From: Gilmore, Tyler J [Tyler.Gilmore@pnnl.gov]
Sent: Friday, January 17, 2014 4:06 PM
To: McDonald, Jeffrey
Cc: Greenhagen, Andrew
Subject: Re: Informal Request (IR) # 3 (IR3-01-10-14)
Attachments: EPA_IR3_for_FG-RPT-017-Final.pdf

U.S. Environmental Protection Agency Informal Request #3
Regarding: FG-RPT-017, Revision 1, SUPPORTING DOCUMENTATION: Underground Injection Control Class VI Injection Well Permit
Applications for FutureGen 2.0 Morgan County UIC Wells 1, 2, 3, and 4

IR 01-10-2014_5

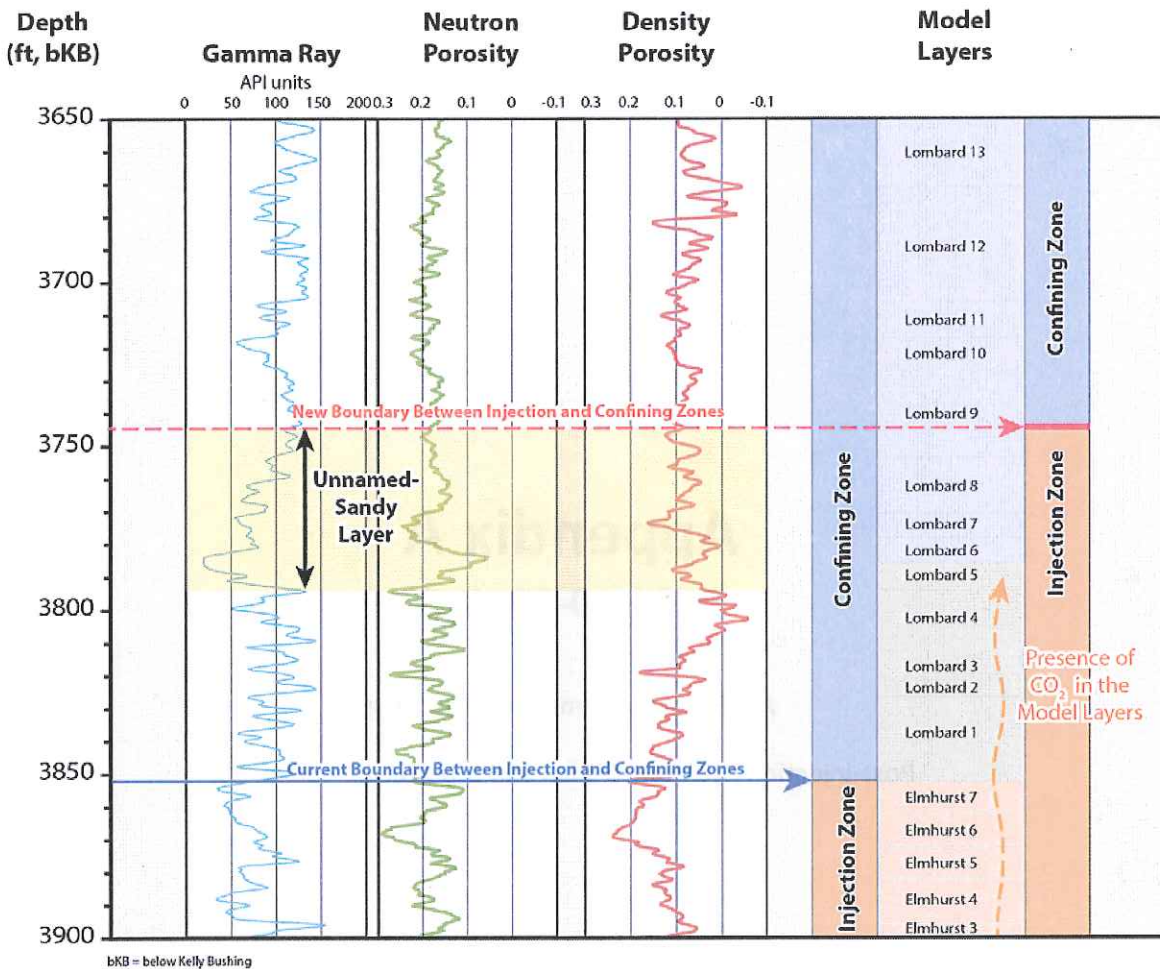
01-10-2014: Email from Jeff McDonald (U.S. EPA Region 5) to Tyler Gilmore (Alliance): "Informal Request (IR) #3 (IR3_01-10-14)"					
Requests based on the text application					
IR #	Subject	Page	Doc. Sec.	Par.	EPA Comment / Question / Request
01-10-2014_5	PISC	3.27 to 3.34	7.1.3 and 3.1.6		<p>"The computational model results indicate that a small fraction of the injected CO₂ will enter the lower part of the Lombard formation, if authorized under any UIC permits, the injection zone will need to include that lower part of the Lombard. Please determine what members or submembers of the Lombard are expected to receive CO₂ and will therefore be part of any permitted injection zone."</p>
					<p>The computation model results indicate that the Model Layer "Lombard 5" is the top unit containing a fraction of injected CO₂ during the 100-year simulation. However, because geophysical logs indicate the presence of an unnamed thin sandy layer above Lombard 5 (see graphic in Appendix A), the Alliance determined that this thin sandstone should also be part of the injection zone.</p> <p>In conclusion, based on the current knowledge of the geology at the FGA1 stratigraphic well, the top of the injection zone is set at 3,745 ft bKB (or 3,731 ft below ground surface), which is in the lower part of the model layer "Lombard 9" (Appendix A)</p> <p>KB = below Kelly Bushing</p>

Determination of the Top of the Injection Zone, based on Geophysical Logs and Modeling Results

Figure 2. Updated and Revised Plan for Monitoring Wells.

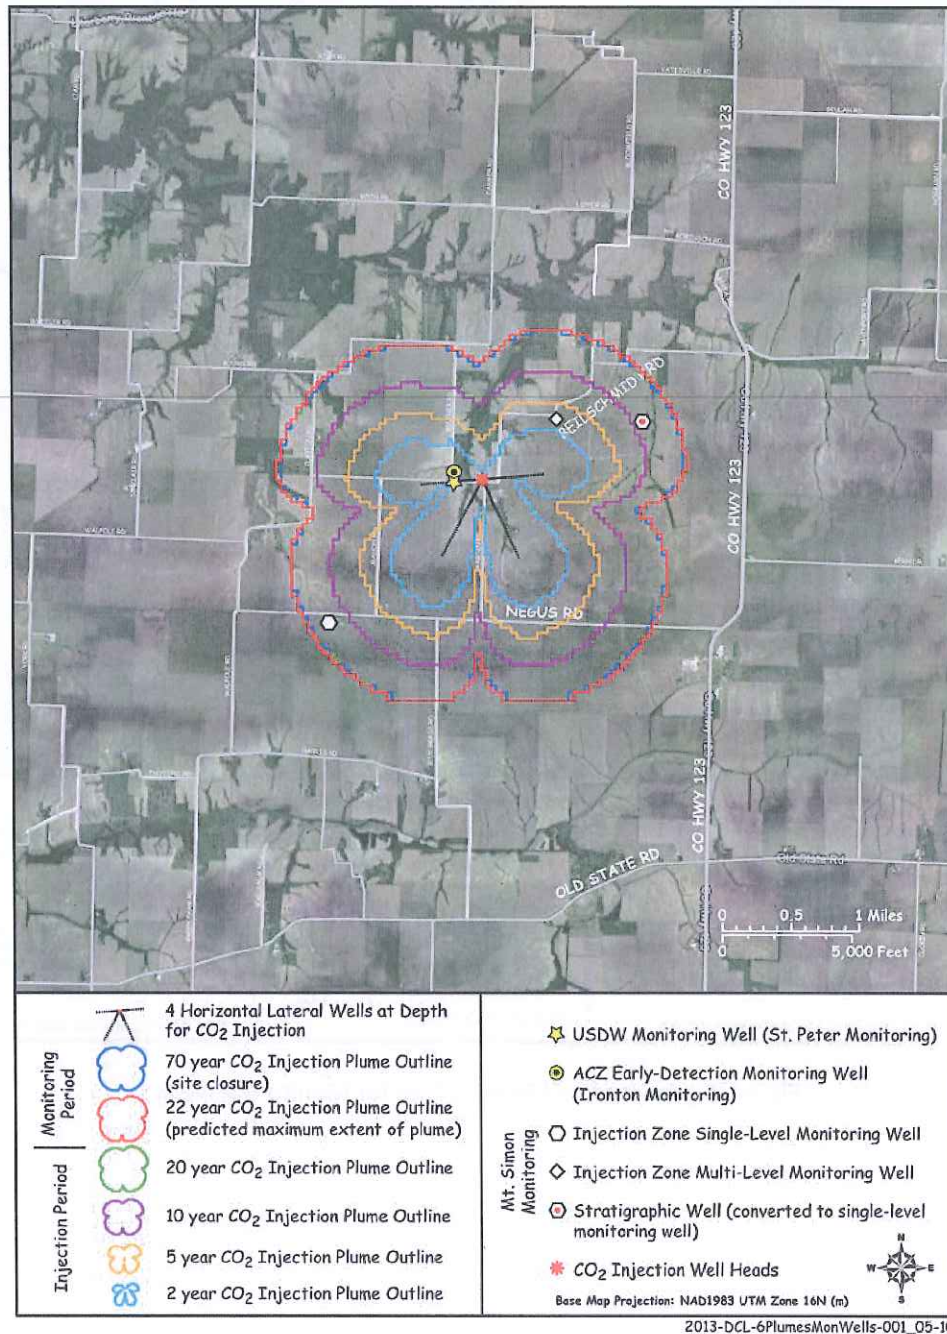
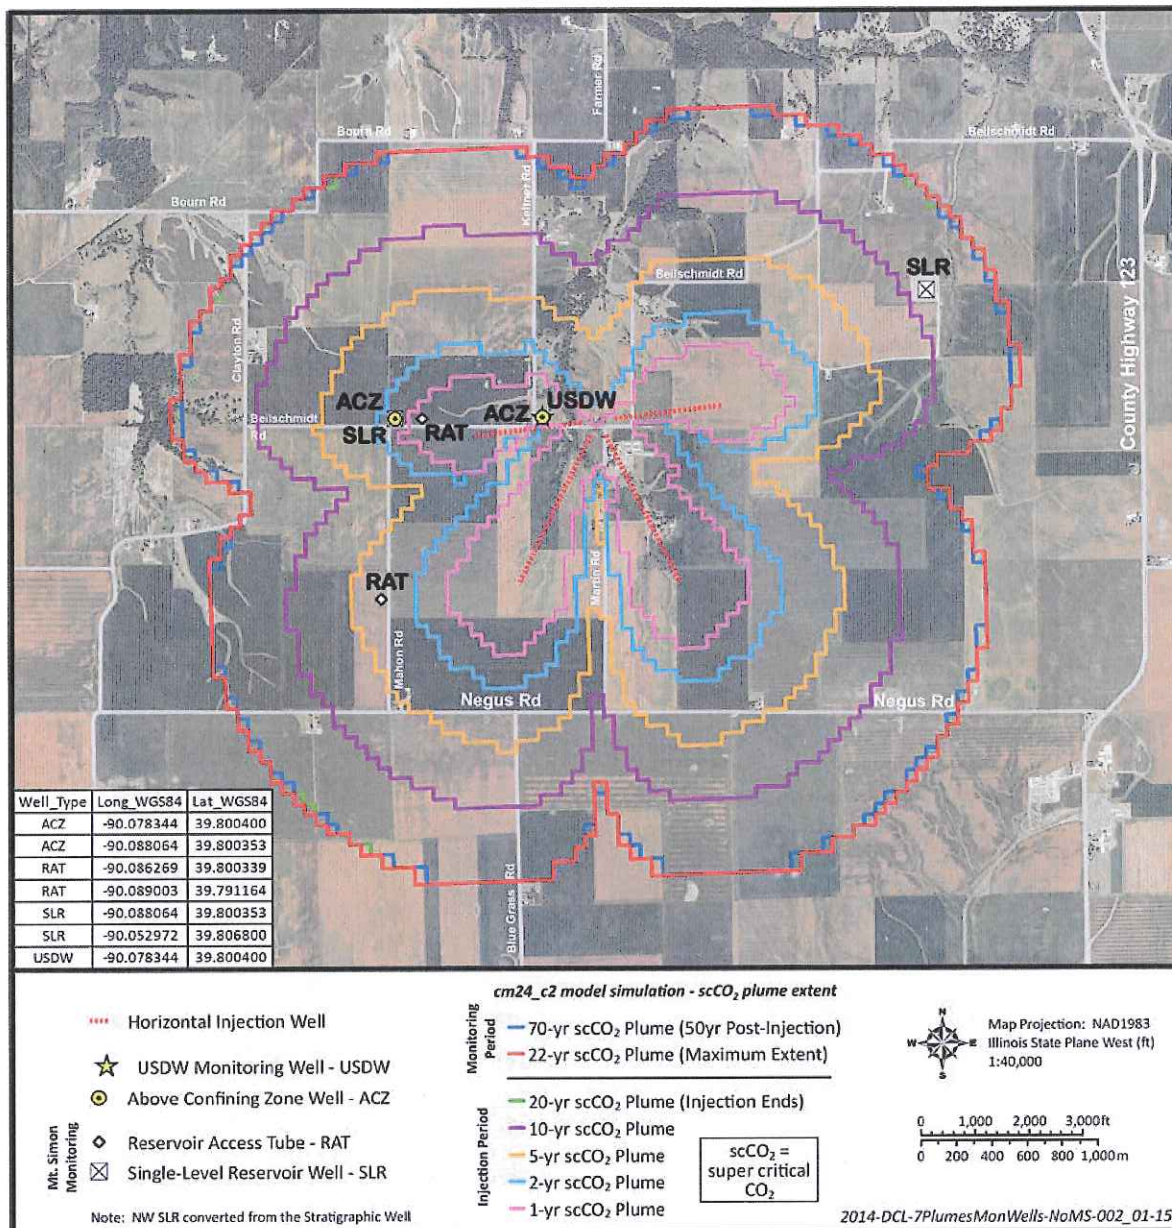
01-10-2014_6	PISC and T&M	7.5	7.2 and 5.2		<p>"Specific locations of monitoring wells need to be identified for any permit decision including what specific parameters will be monitored for."</p>
					<p>The Alliance has modified the monitoring network design since the UIC permit application was submitted. A discussion, which includes monitored parameters, and a location map showing the updated and revised monitoring well network are provided in Appendix B.</p>
01-10-2014_7	PISC and T&M	7.5	7.2.2		<p>"Please state whether FGA will use a "multi-level monitoring system within a single casing string with multiple sample intervals" or a "multi-level piezometer installation."</p>
					<p>The Alliance has modified the monitoring network design since the UIC permit application was submitted by eliminating this "multi-level monitoring well". The previously planned multi-level completion has been replaced by two fully cased reservoir access tubes (RATs) that will be installed within the boundaries of the simulated 5-year CO₂ plume. The RATs will extend to the base of the reservoir and into the Precambrian bedrock. The RATs will be non-perforated, cemented casings used to monitor CO₂ arrival and quantify saturation levels via downhole pulsed-neutron capture (PNC) geophysical logging across the reservoir and confining zone.</p> <p>A discussion and location map showing the updated and revised monitoring well network is provided in Appendix B.</p>

As part of the project's design optimization, the monitoring well network design has been revised (Figure 2) to increase its effectiveness, simplify its engineering design, and hopefully eliminate any permitting challenges that might have been associated with the MLR. The revisions include eliminating the MLR well in favor of adding two fully cased reservoir access tube (RAT) wells. The revised design includes a total of seven monitoring wells summarized in Table 1 and as follows:

The most recent monitoring well design includes five deep monitoring wells and two RAT wells as listed in Table 1.
